Model: Stinger-P3/P4		Date: 30-Sep-99	No.: RG031001
Subject: Abnormal Print Image for the Stinger-P3		Prepared by: M. Kitajima	
From: Technical Service Dept., GTS Division			
Classification:	<input checked="" type="checkbox"/> Troubleshooting <input type="checkbox"/> Part information <input type="checkbox"/> Action required <input type="checkbox"/> Mechanical <input type="checkbox"/> Electrical <input type="checkbox"/> Service manual revision <input type="checkbox"/> Paper path <input type="checkbox"/> Transmit/receive <input type="checkbox"/> Retrofit information <input type="checkbox"/> Other ()

Model: Stinger-P		Date: 31-Mar-00	No.: RG031003
Subject: Release of stinger-P3II/P4II		Prepared by: M. Kitajima	
From: Technical Services Dept., GTS Division			
Classification:	<input type="checkbox"/> Troubleshooting <input type="checkbox"/> Part information <input type="checkbox"/> Action required <input type="checkbox"/> Mechanical <input type="checkbox"/> Electrical <input type="checkbox"/> Service manual revision <input type="checkbox"/> Paper path <input type="checkbox"/> Transmit/receive <input type="checkbox"/> Retrofit information <input checked="" type="checkbox"/> Other ()

Th

Stinger – P4II

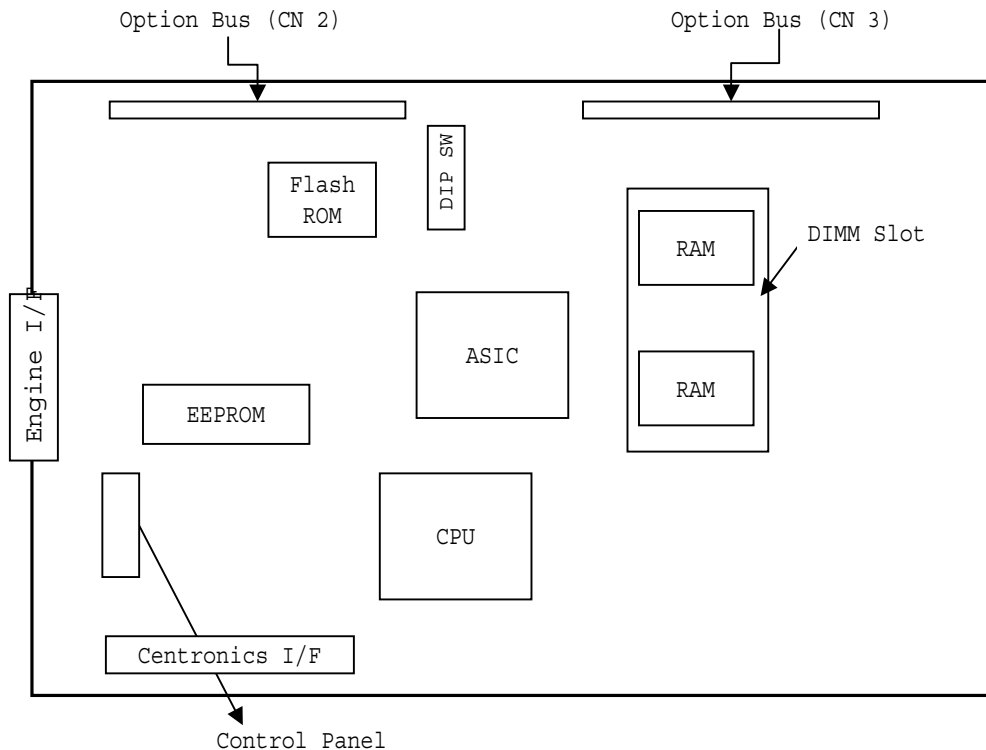
The built-in tray for the Stinger P4 can only hold A4/letter size. However, the Stinger-P4II tray can handle A4/letter or shorter.

The paper feed speed for the Stinger-P3II/P4II is the same as that of the Stinger-P3/P4. However, the feeding interval has been decreased in the Stinger-P3II/P4II, allowing a higher PPM.
